# Access Compliance Report

## Public Rights-of-Way

### (Curb Ramps)

Intersection ID: 3924	Main Street: COPPERPLATE_RD	Cross Street: WILBURN_PARK_CT	Location: NW
ADA ID: D9BEFD9248A2	Ramp Type: Perp	Initial Pass/Fail: Fail	Overall Compliance: No
Severity Score: 13.75			
Codes/Mitigation Info/Possible Solution		Field Measurements/Component Compliance

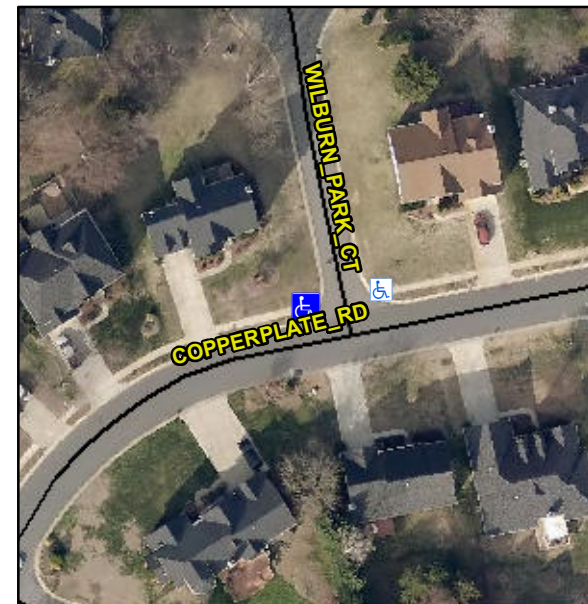
**Not Found, R304.2.2, R304.5.3**

Compliance	Description	Data	Compliance	Description	Data
N/A	Ramp Length (in)	45.0	No	Ramp Slope (%)	11.8
Yes	Ramp Width (in)	170.0	No	Ramp XSlope (%)	4.5
N/A	Flare Type LT	N/A	N/A	Flare Type RT	N/A
N/A	Flare Slope LT (%)	N/A	N/A	Flare Slope RT (%)	N/A
N/A	Flare Traversable LT?	N/A	N/A	Flare Traversable RT?	N/A
N/A	Landing Length (in)	N/A	N/A	DWS Provided?	N/A
N/A	Landing Width (in)	N/A	N/A	DWS Contrast?	N/A
N/A	Landing Slope (%)	N/A	N/A	DWS Length (in)	N/A
N/A	Landing X Slope (%)	N/A	N/A	DWS Full Width?	N/A
N/A	Landing Curb? (Y/N)	N/A	N/A	DWS Offset (in)	N/A
N/A	Shared Landing?	N/A			
N/A	Gutter Ponding?	N/A	N/A	Gutter Slope (%)	N/A
N/A	Gutter Lip Ht (in)	2.0	N/A	Gutter X Slope (%)	N/A
N/A	Painted X Walk1?	No	N/A	Painted X Walk2?	N/A
	X Walk 1 Direction	To E		X Walk 2 Direction	N/A
N/A	X Walk 1 Width (in)	N/A	N/A	X Walk 2 Width (in)	N/A
	X Walk 1 Slope (%)	2.2		X Walk 2 Slope (%)	N/A
	X Walk 1 X Slope (%)	3.3		X Walk 2 X Slope (%)	N/A

**Remove & Replace Entire Ramp.**
